**RE : Responses to Peer Review Comments for Arkell Subdivision, South of Arkell
Road and East of Watson Road South, Puslinch, ON
HGC Project #: 02600117**

As requested, please see HGC Noise Vibration Acoustics responses to the Peer Review comments from Valcoustics Canada Ltd. dated April 21, 2025. The comments are presented below, and our responses follow in *italics*.

Figure 3: Proposed Concept Plan Showing Ventilation and Acoustic Barrier Requirements

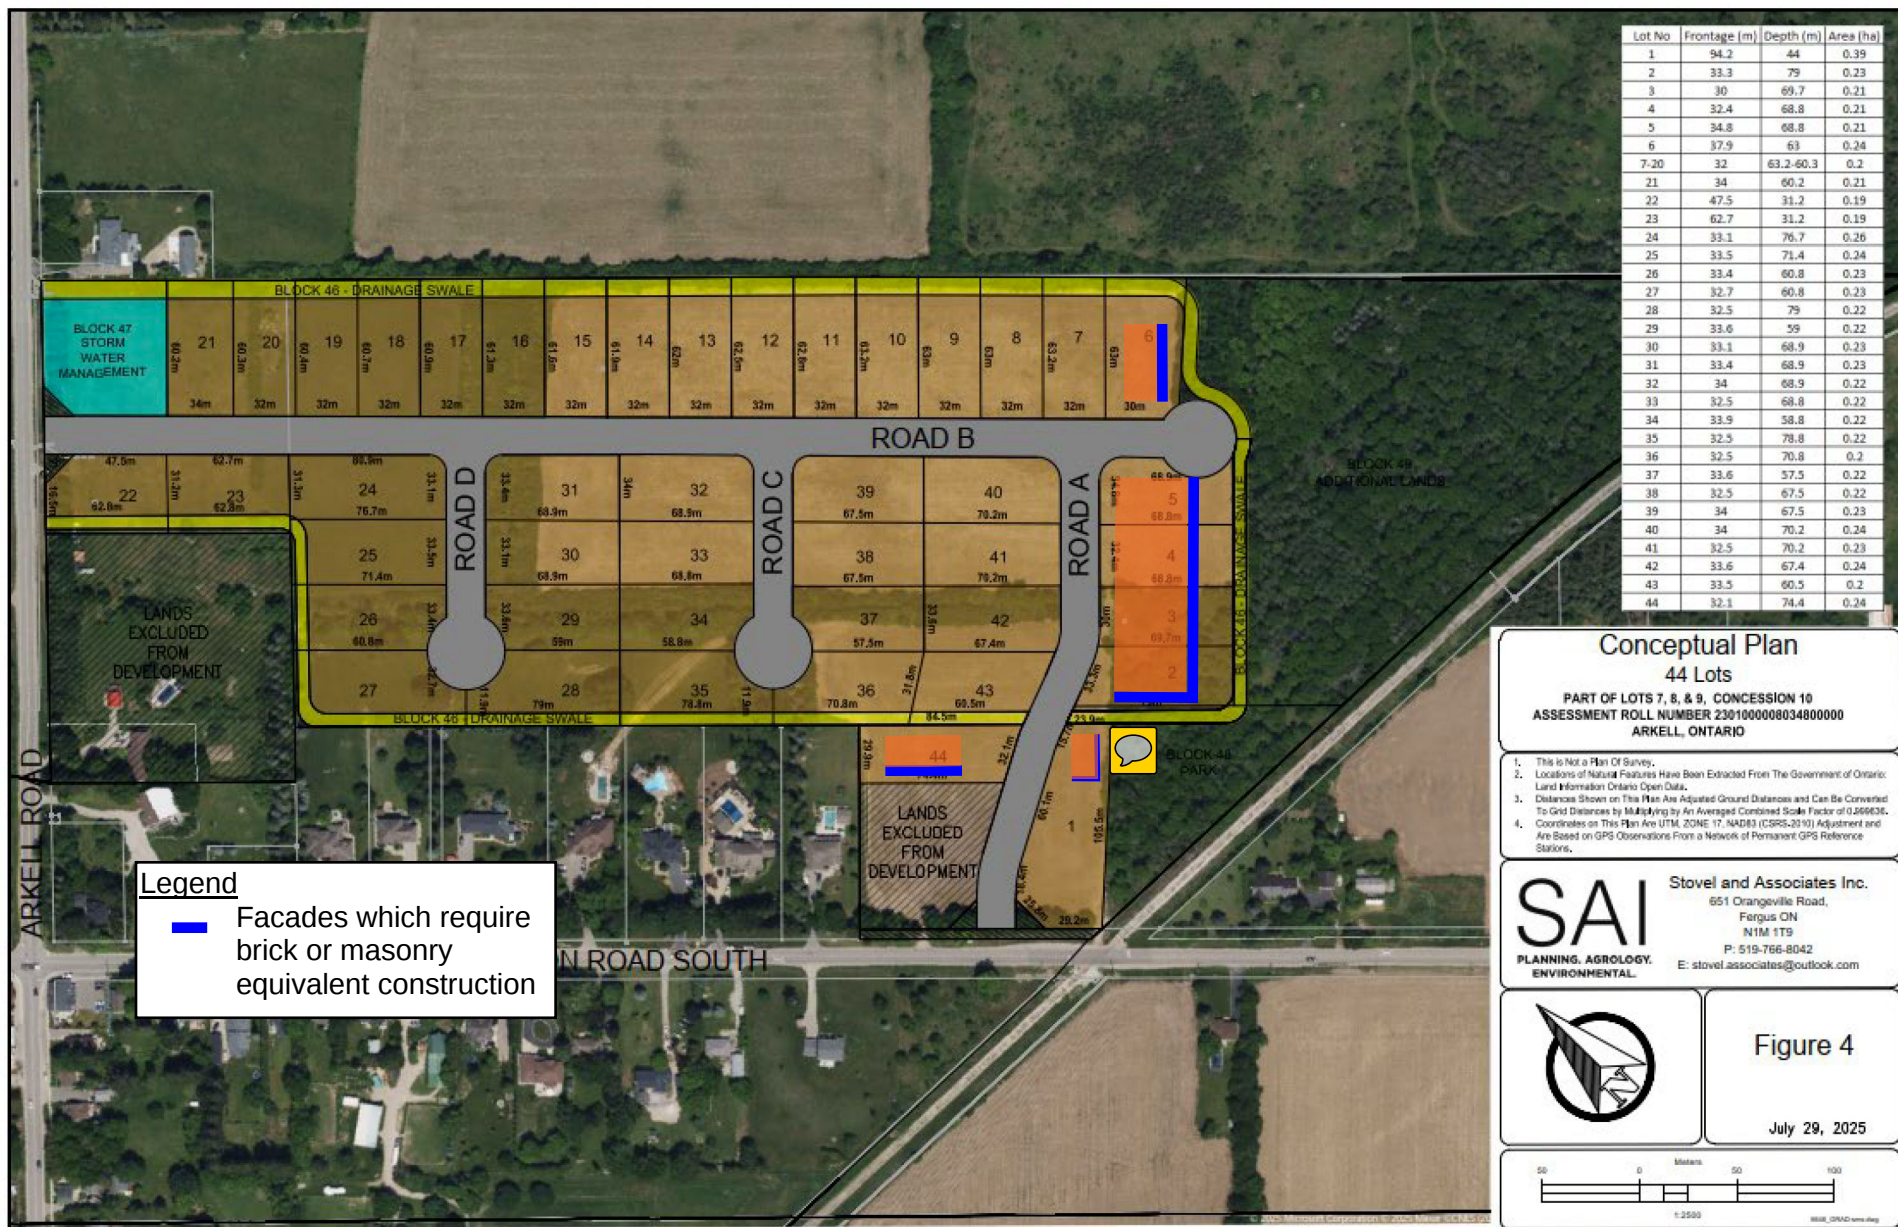
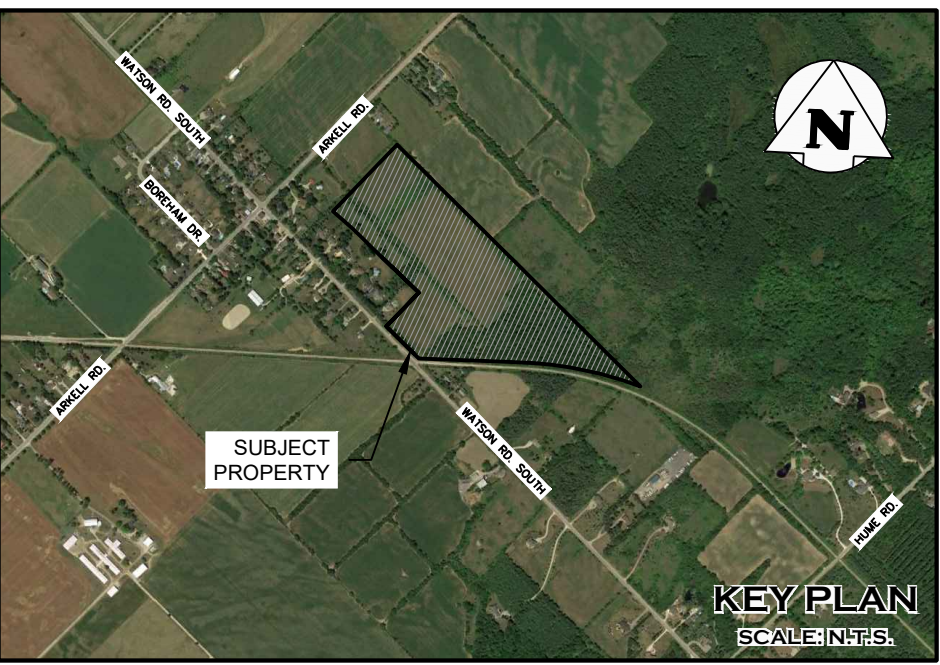
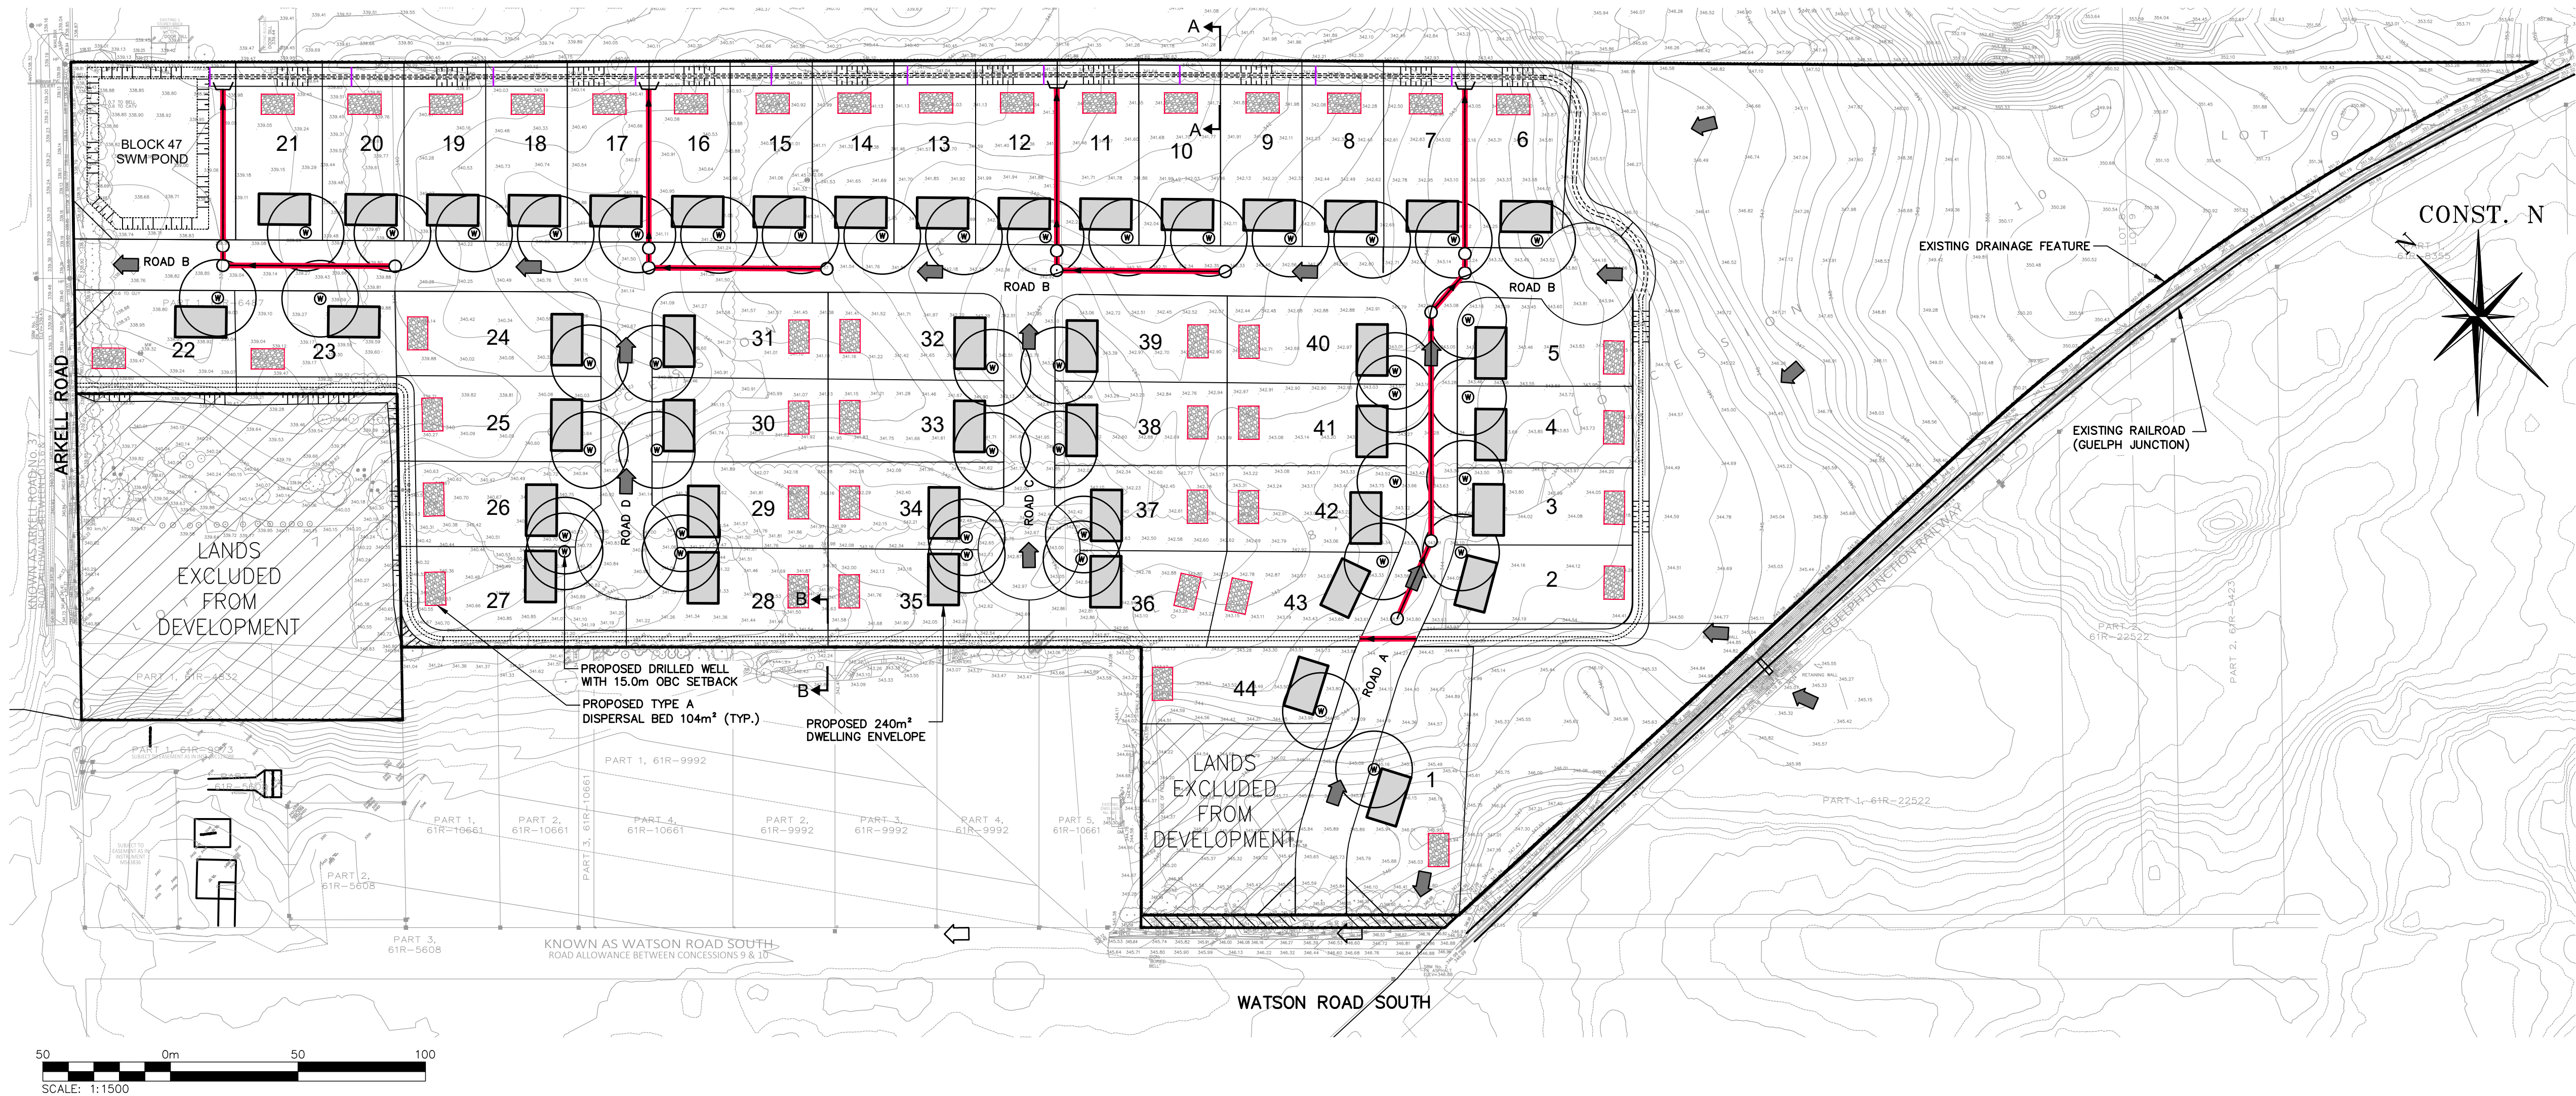
- f. The noise mitigation summary provided as Table 7 should include the locations where brick veneer or equivalent masonry construction is required for the exterior walls. Review of the recommended locations shown on the first Figure 4 indicate that in addition to the southeast façade, the southwest façade should also be brick veneer or equivalent masonry construction.

The table is reprinted here with the extra column. Figure 3 is attached.
